**Planning & Development Division**  
*Planning & Economic Development Department*

<b>File Number</b>	PL 24-036	<b>Contact</b>	Jason Mozol, <a href="mailto:jmozol@duluthmn.gov">jmozol@duluthmn.gov</a>	
<b>Type</b>	MU-I Planning Review	<b>Planning Commission Date</b>	July 9, 2024	
<b>Deadline for Action</b>	<b>Application Date</b>	June 7, 2024	<b>60 Days</b>	July 6, 2024
	<b>Date Extension Letter Mailed</b>	May 21, 2024	<b>120 Days</b>	September 4, 2024
<b>Location of Subject</b>	1420 London Rd			
<b>Applicant</b>	Kyle Hammer	<b>Contact</b>		
<b>Agent</b>	Kelly, Mortenson, DSGW	<b>Contact</b>		
<b>Legal Description</b>	010-1440-2100 and 010-1440-12110			
<b>Site Visit Date</b>	June 24, 2024	<b>Sign Notice Date</b>	June 20, 2024	
<b>Neighbor Letter Date</b>	May 24, 2024	<b>Number of Letters Sent</b>	32

**Proposal**

The applicant is proposing to demolish the existing dental clinic and construct a new 7,000 sq. ft clinic building. There is not a MU-I district plan for the site, so individual Planning Review is required.

SITE PLAN  
 sheet title  
 sheet number

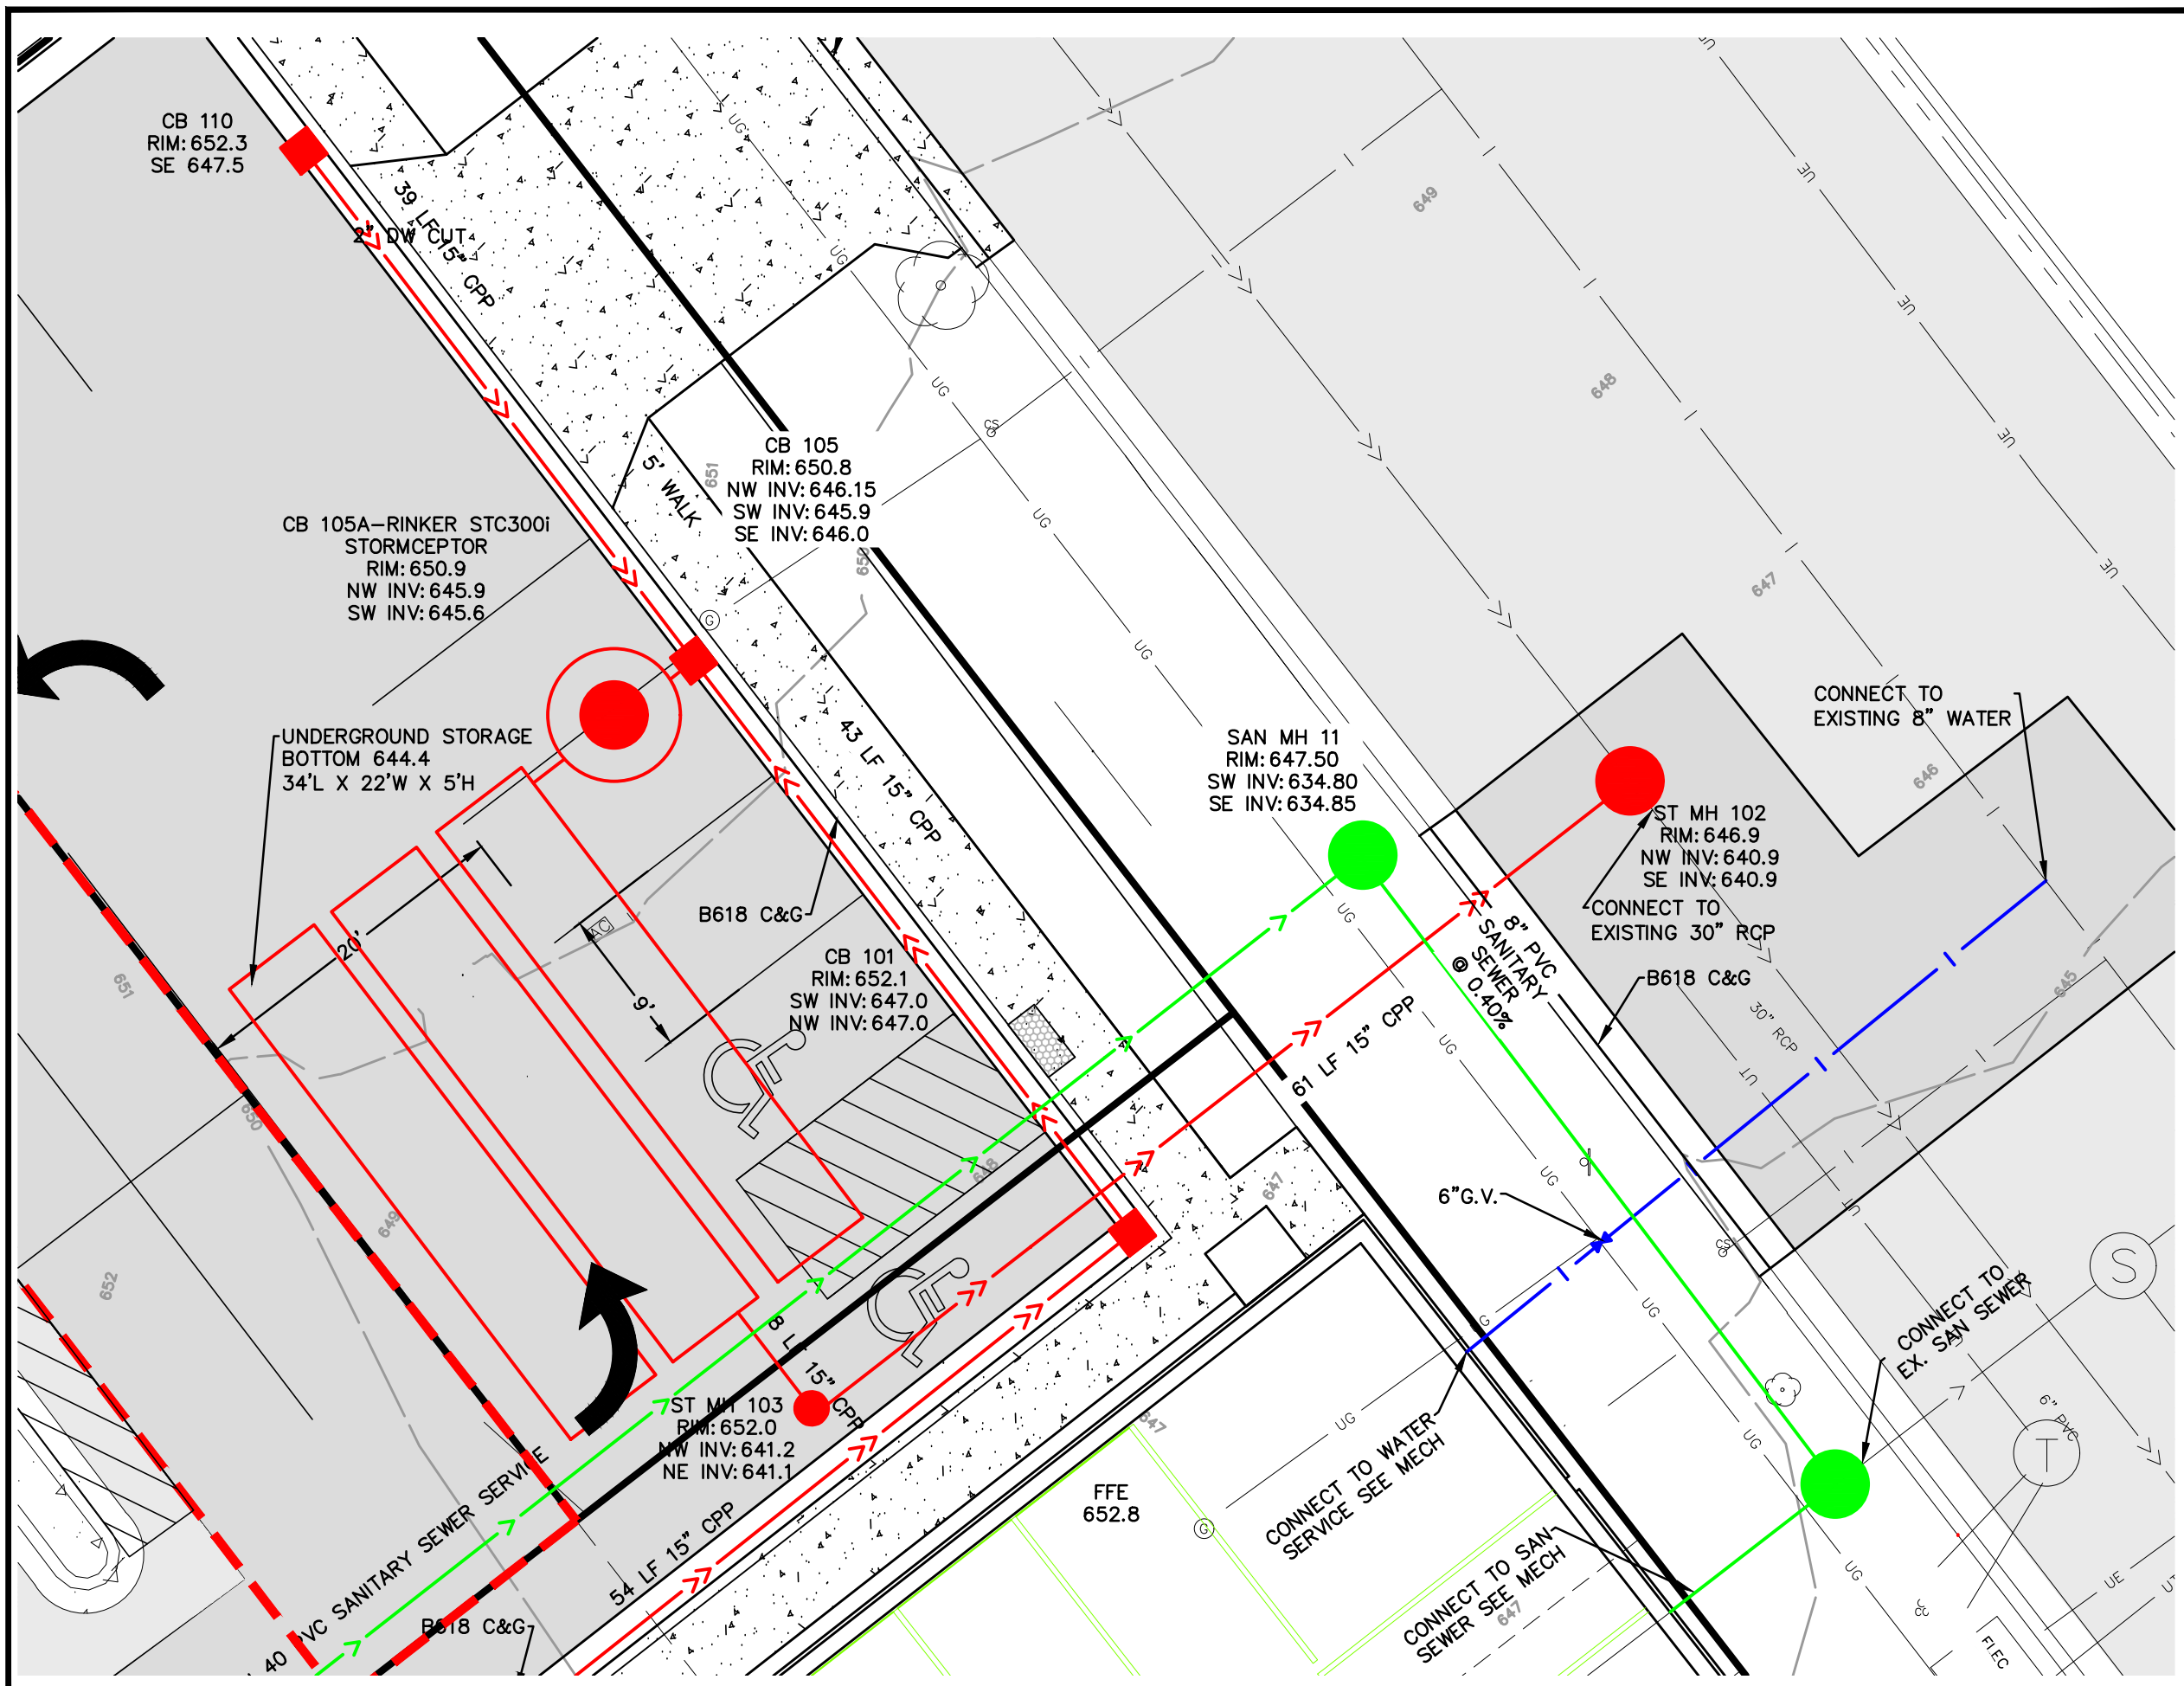
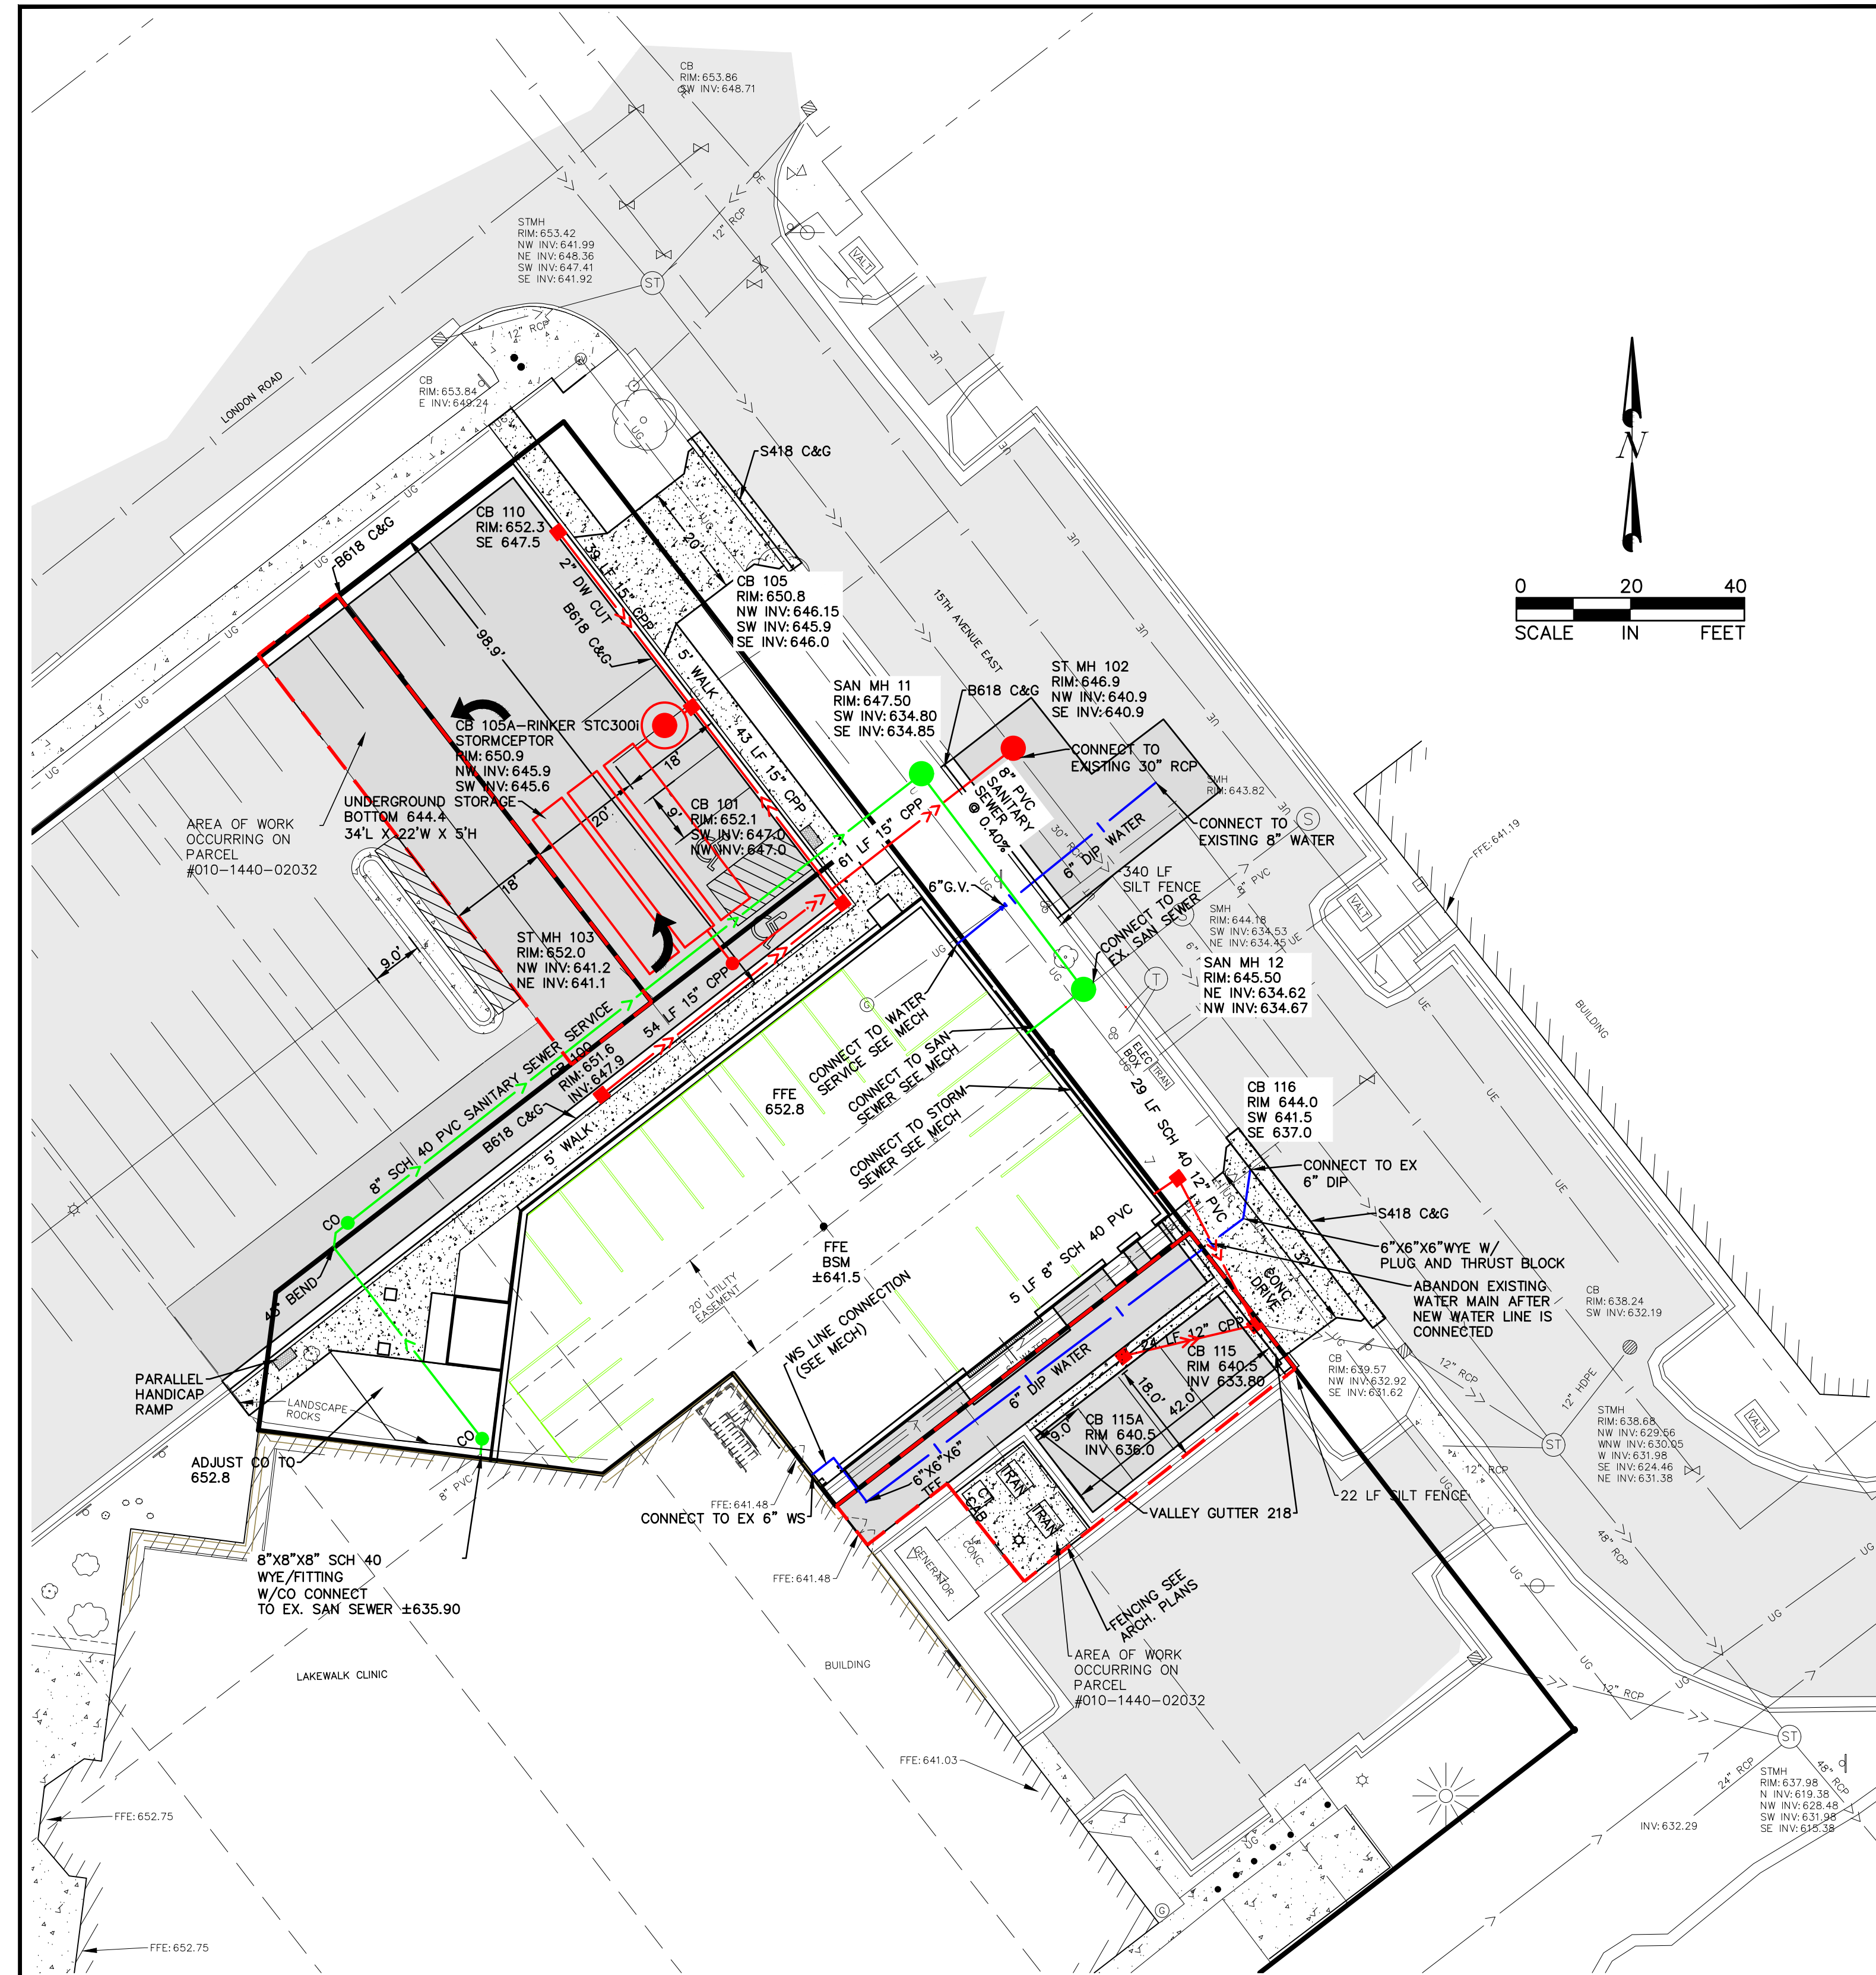
- 2) UDC 50-24 Sec. (Parking and loading). A maximum of 42 parking spaces are allowed on this site. 24 parking spaces will be provided, 14 in an underground ramp and 10 in a surface lot. Parking aisles and spaces meet the dimensional standards. 3 bike parking spaces are required. The applicant must submit a site plan and exhibit depicting the location of bike parking and rack design, and this must be approved by the Land Use Supervisor prior to receiving a building permit.

- 3) UDC Sec. 50-25 (Landscaping and tree preservation). This project must provide frontage landscaping along London Rd and S 15<sup>th</sup> Ave E, tree canopy coverage of parking areas, interior parking lot landscaping and replace trees removed from the site. A landscape plan was submitted that lacked calculations for canopy coverage and interior parking lot plantings, and placed frontage landscaping in the right-of-way. The applicant must submit landscaping plan that meet Sec. 50-25 standards, and this must be approved by the Land Use Supervisor prior to receiving a building permit.

- 1) The applicant shall submit a site plan and exhibit depicting conformity with bike parking requirements of the UDC;
- 2) Applicant shall submit a landscaping plan that fully conforms with the requirements of the UDC;
- 2) Applicant shall submit a lighting plan with photometric plan and drawings for fixtures that fully conforms to the requirements of the UDC;
- 3) Applicant shall construct and maintain the project as identified in the attached exhibits.
- 4) Any alterations to the approved plans that do not alter major elements of the plans may be approved by the Land Use Supervisor without further Planning Commission; however, no such administrative approval shall constitute a variance from the provisions of UDC Chapter 50.
